ADDENDUM #1

Reference: Gunther Trades Building Dance Studio
Utah Valley University – Orem, Utah
DFCM Project No. 08321790

ADDENDUM NO. I

Utah Valley University
Gunther Trades Building
New Dance Studio Interior Remodel
Orem, Utah

**SD-01
MD101**

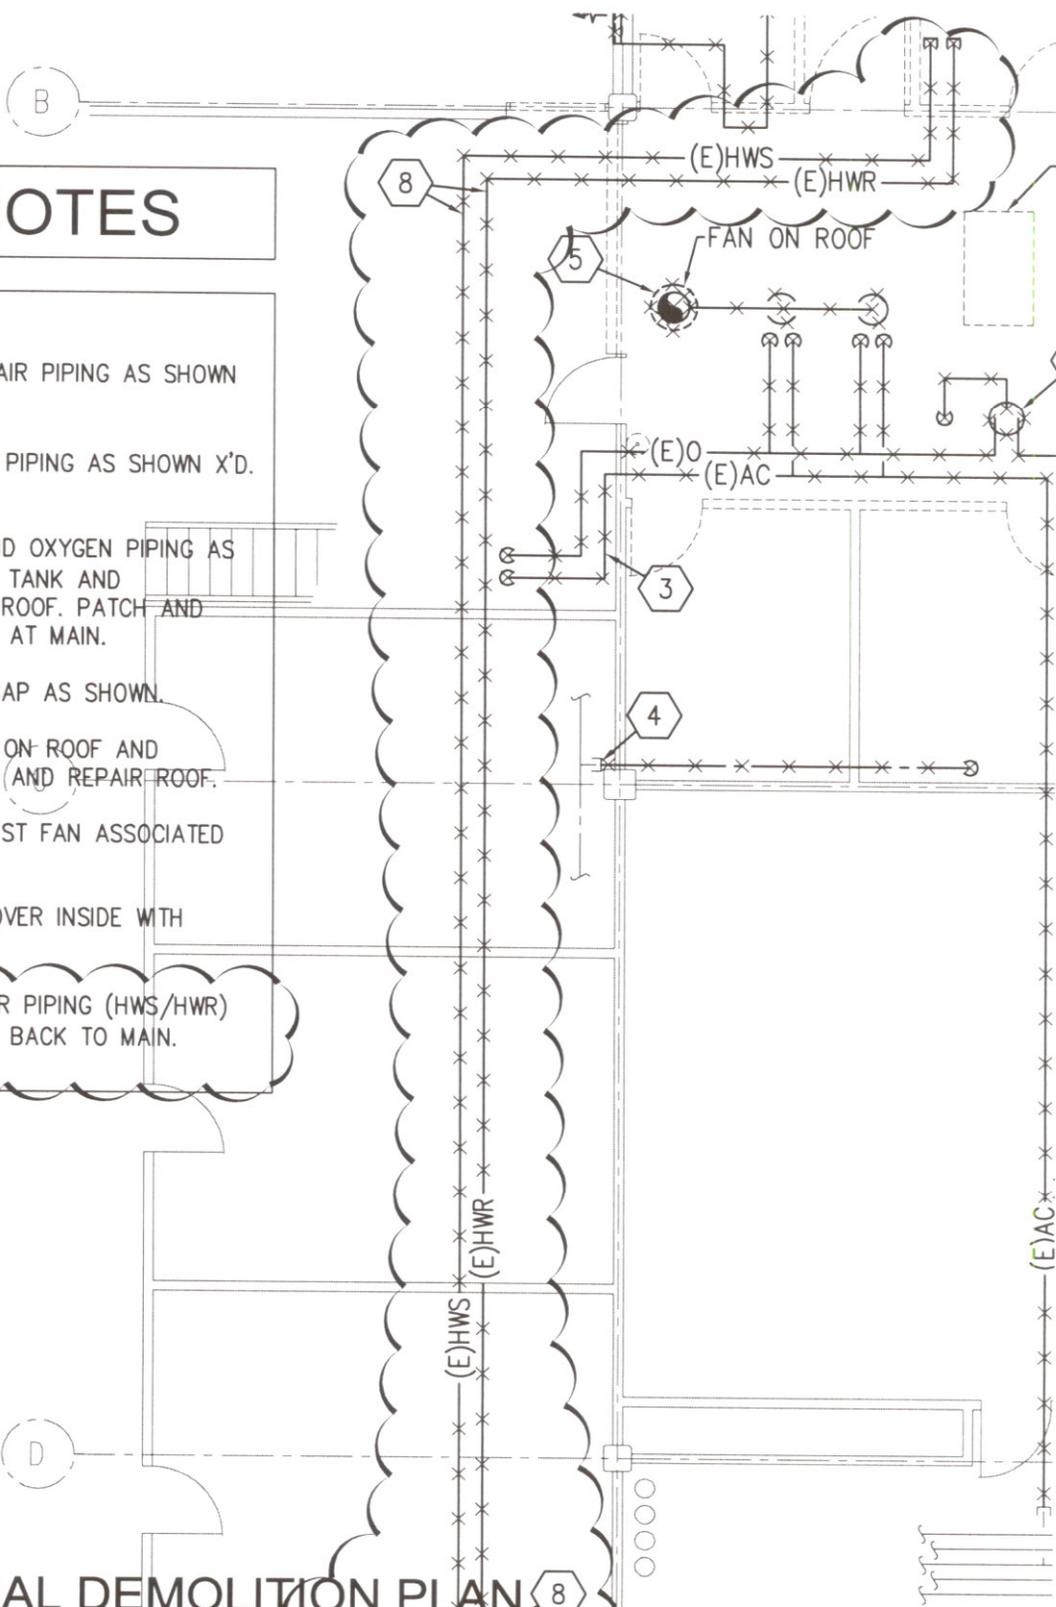
1. Remove existing heating water piping as shown x'd. See attached supplemental drawing SD-01 (MD101).

1. REMOVE EXISTING COMPRESSED AIR PIPING AS SHOWN X'D. CAP BACK AT MAIN.
2. REMOVE EXISTING NATURAL GAS PIPING AS SHOWN X'D. CAP BACK AT MAIN.
3. REMOVE EXISTING ACETYLENE AND OXYGEN PIPING AS SHOWN X'D. REMOVE ACETYLENE TANK AND ACCESSORIES AND PIPING THRU ROOF. PATCH AND REPAIR ROOF. CAP PIPING BACK AT MAIN.
4. REMOVE EXISTING WATER LINE. CAP AS SHOWN.
5. REMOVE EXISTING EXHAUST FAN ON ROOF AND ASSOCIATED DUCT WORK. PATCH AND REPAIR ROOF.
6. REMOVE EXISTING INDOOR EXHAUST FAN ASSOCIATED DUCTWORK.
7. EXISTING LOUVER TO REMAIN. COVER INSIDE WITH INSULATION AND SHEET METAL.
8. REMOVE EXISTING HEATING WATER PIPING (HWS/HWR) AS SHOWN X'D. CAP AND VALVE BACK TO MAIN.

**SD-02
M101**

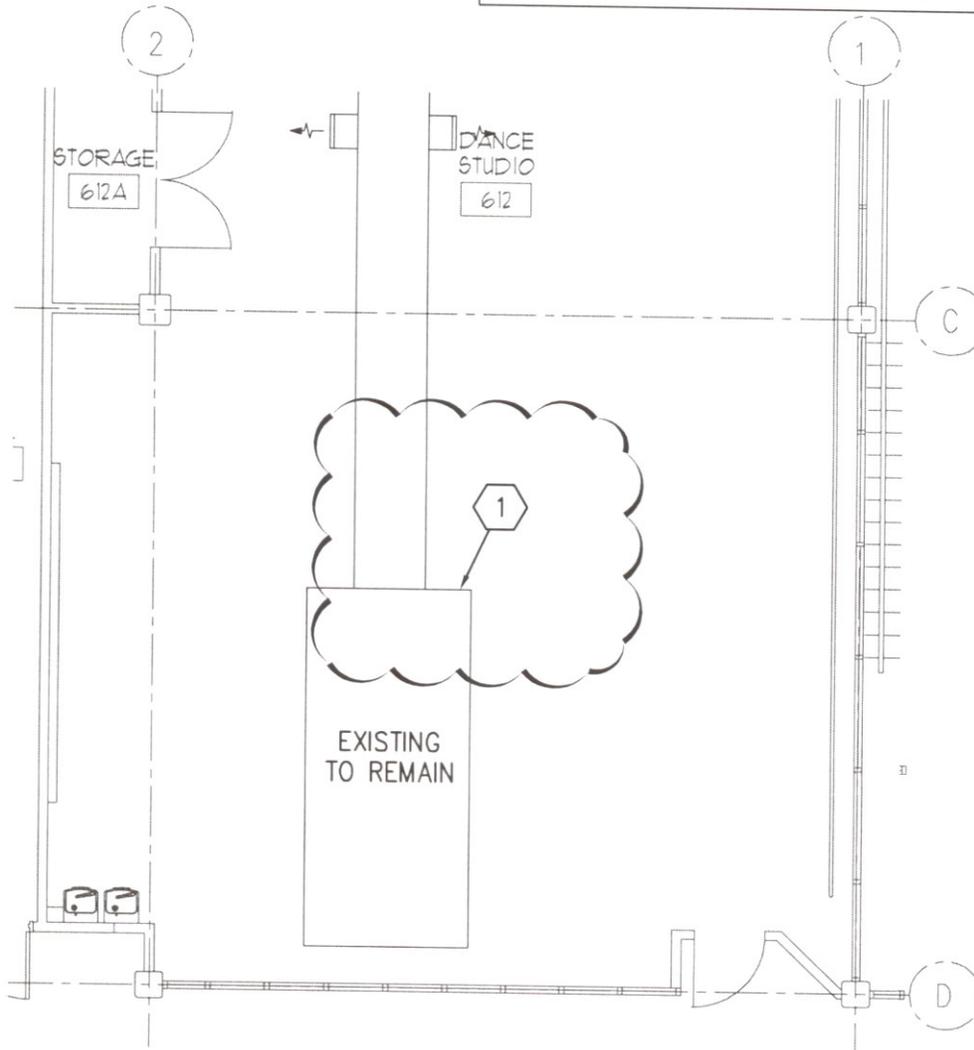
1. Provide and install new vibration isolators at all hanging points (approximately 4 locations) of the existing air handler suspended from structure. Field verify existing conditions. See attached supplemental drawing SD-02 (M101).

1. PROVIDE AND INSTALL NEW VIBRATION ISOLATORS AT ALL HANGING POINTS (APPROX. 4) OF EXISTING AIR HANDLER SUSPENDED FROM STRUCTURE. FIELD VERIFY EXISTING CONDITIONS.

E102

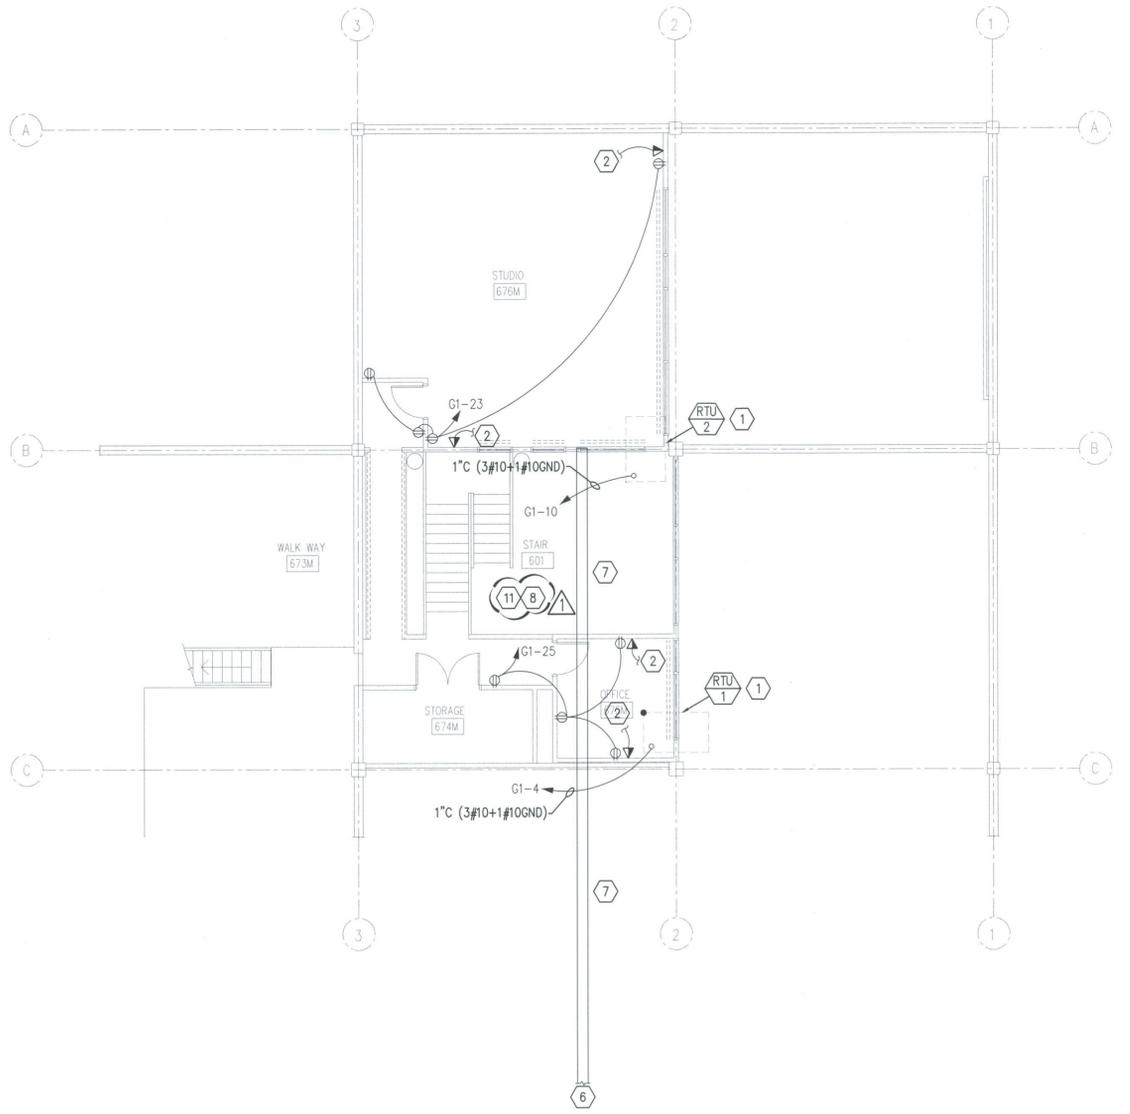
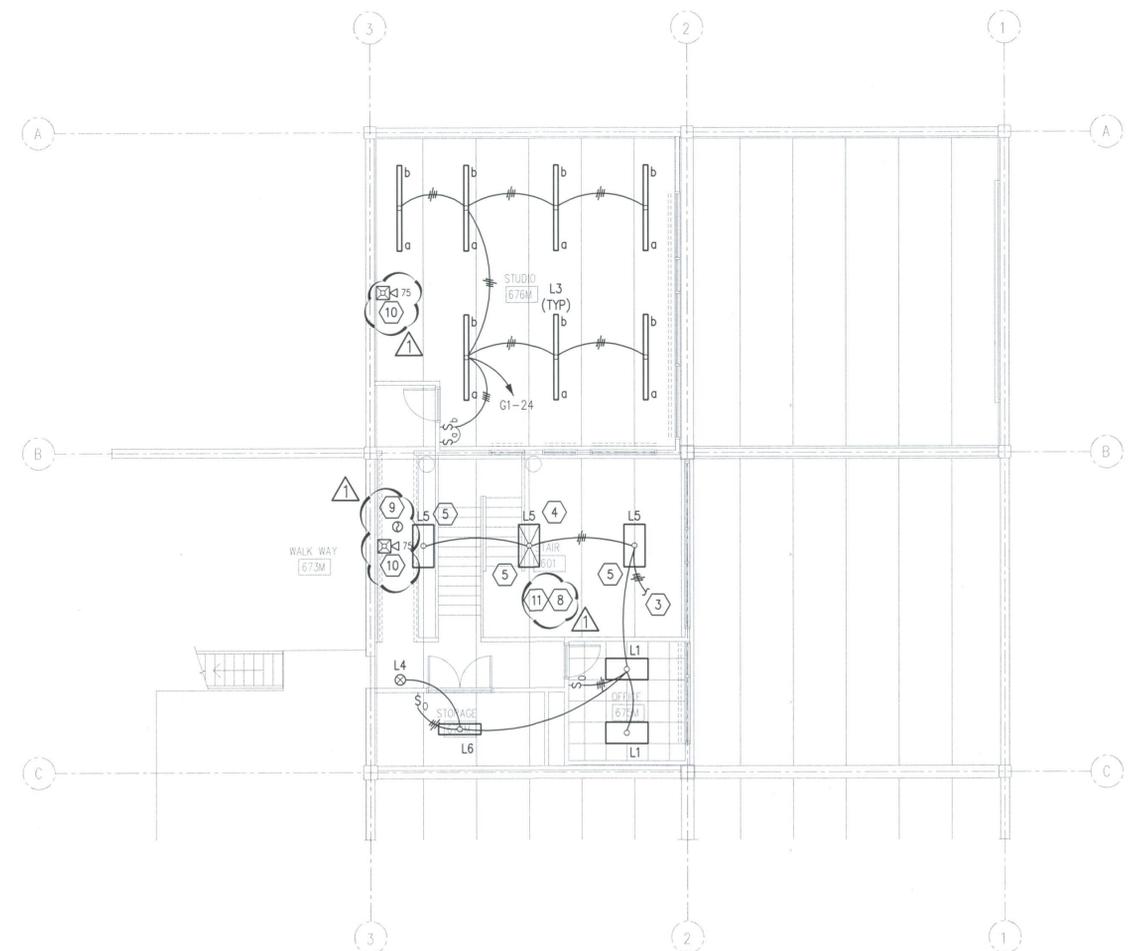
1. Provide smoke detectors and horn-strobes UL listed compatible with existing fire alarm system. See attached supplemental drawing E102.
2. Do not support electrical from the roof deck without engineering provided to show the deck can support the additional load as directed by keyed note 11.
3. Provide separation of raceways from roof deck as directed by keyed note 8.

- # KEYED NOTES CONT
- ANY CONDUIT INSTALLED UNDER THE ROOF DECKING SHALL BE INSTALLED AND SUPPORTED SO THAT THE OUTSIDE SURFACE OF THE CONDUIT IS GREATER THAN 1 1/2" FROM THE NEAREST SURFACE OF THE ROOF DECKING AS REQUIRED BY NEC 300.
 - CONNECT SMOKE DETECTOR TO EXISTING FIRE ALARM SYSTEM.
 - PROVIDE HORN STROBE TO MATCH EXISTING HORN STROBES. CONNECT TO EXISTING FIRE ALARM SYSTEM.
 - STEEL ROOF DECK SHALL NOT BE USED TO SUPPORT LOADS FROM PIPING OR EQUIPMENT, UNLESS NOTED OTHERWISE. HANGER LOADS LESS THAN 50 LBS. MAY BE HUNG FROM THE STEEL ROOF DECK IN CASES WHEN HANGING FROM THE STEEL ROOF DECK CANNOT BE AVOIDED. THE ATTACHMENT METHOD MUST DISTRIBUTE THE LOAD ACROSS THE DECK AS APPROVED BY THE STRUCTURAL ENGINEER.
